**IEEE P802.11
Wireless LANs**

Replacement Description of CCK

Date: November 4, 1998

This document presents a replacement description of the CCK coding scheme in P802.11B/D1.0. This description uses standard notation that is widely used in industry and academia. This text has been written to replace replace sections 18.4.6.4 – 18.4.6.6.

Figure A - CCK Encoder Block Diagram

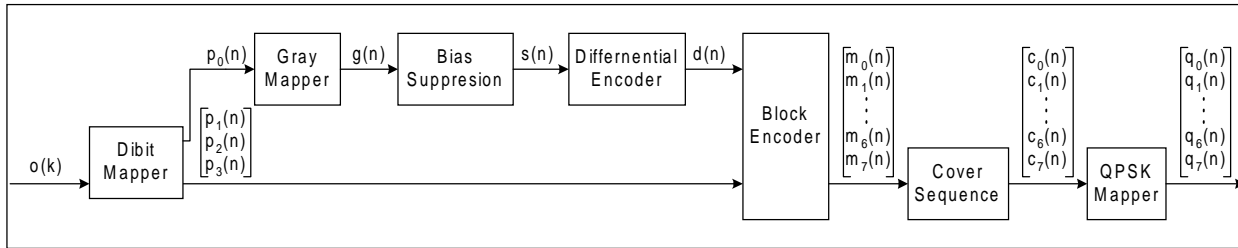
The CCK modulation scheme may be described in terms of a block code over the integers modulo 4. Figure A shows the structure of the CCK encoding scheme.

Figure B - CCK Bias Suppressor

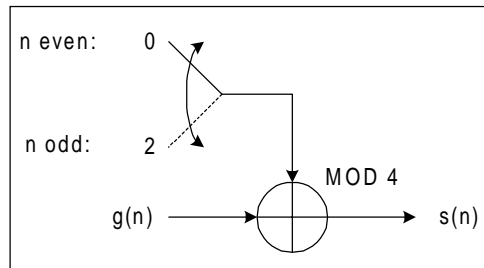
The CCK Bias Suppressor adds 2 to $g(n)$ modulo 4, if n is even. This may be equivalently represented by Equation D.

Figure B shows an implementation of the bias suppressor.

Figure C - CCK Differential Encoder

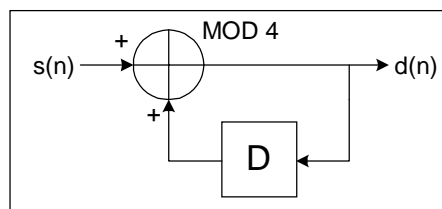
The output of the bias suppressor is differentially encoded by Equation E.

Figure C shows one relization of this differentiator.
